Appendix 3. Photographs of EUT [Internal View]

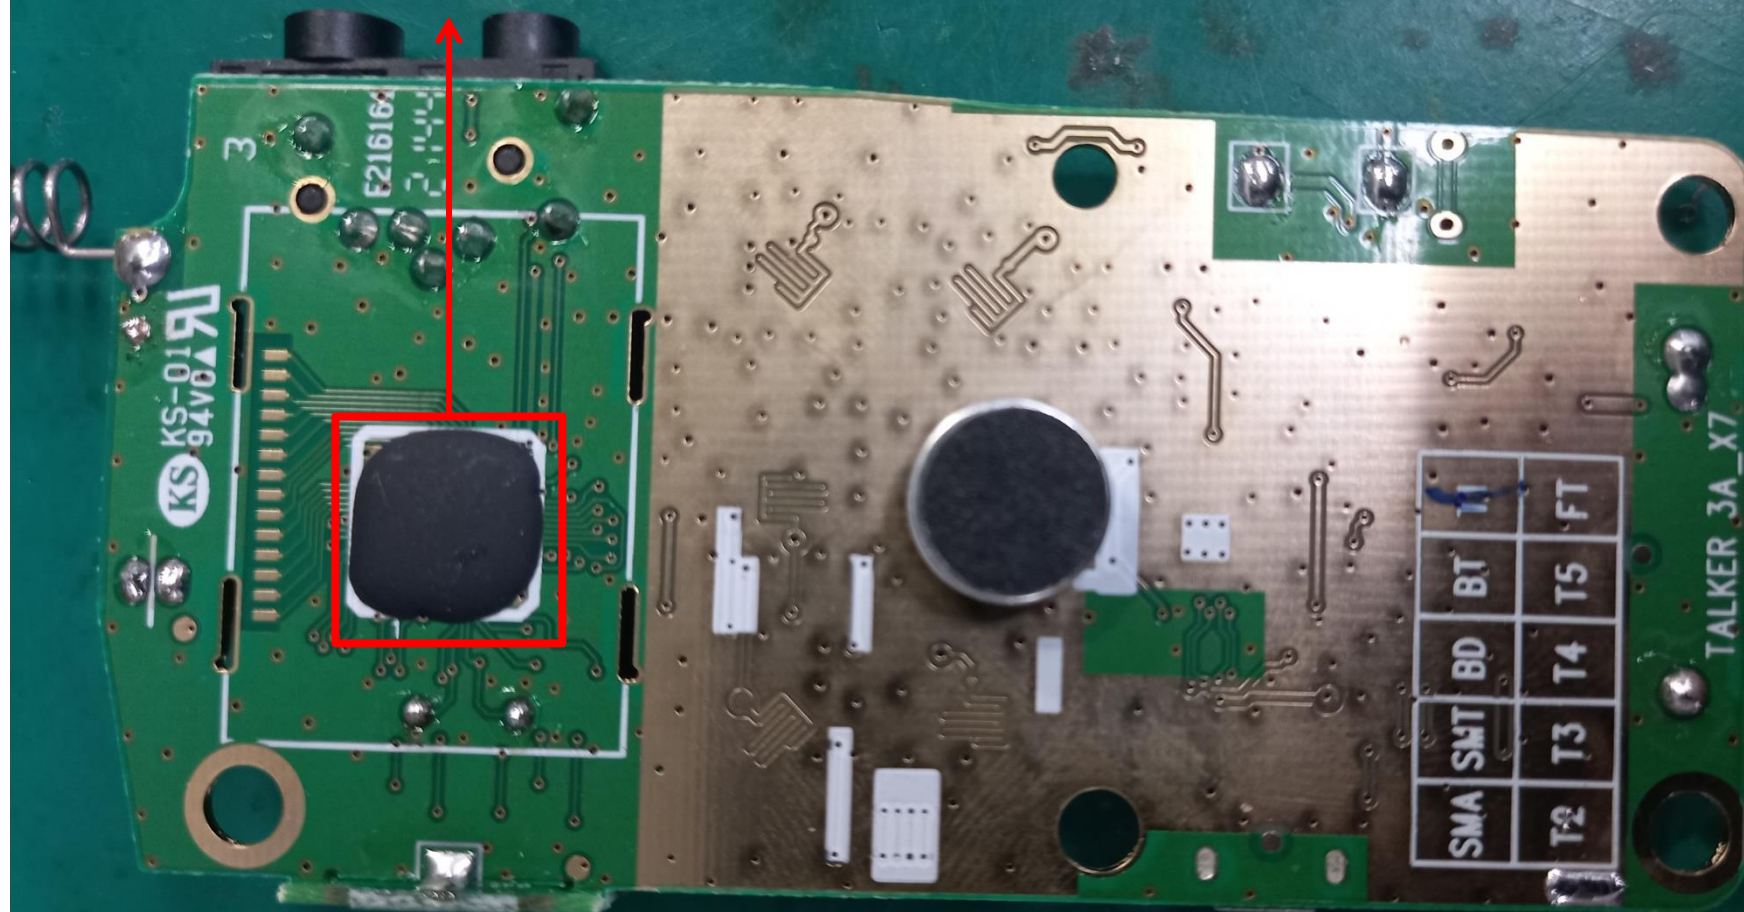
CPU1(CPU) replace from WT56F108 to WT56F216.

IC3(AF Amp.) replace from TDA2822 to D4890
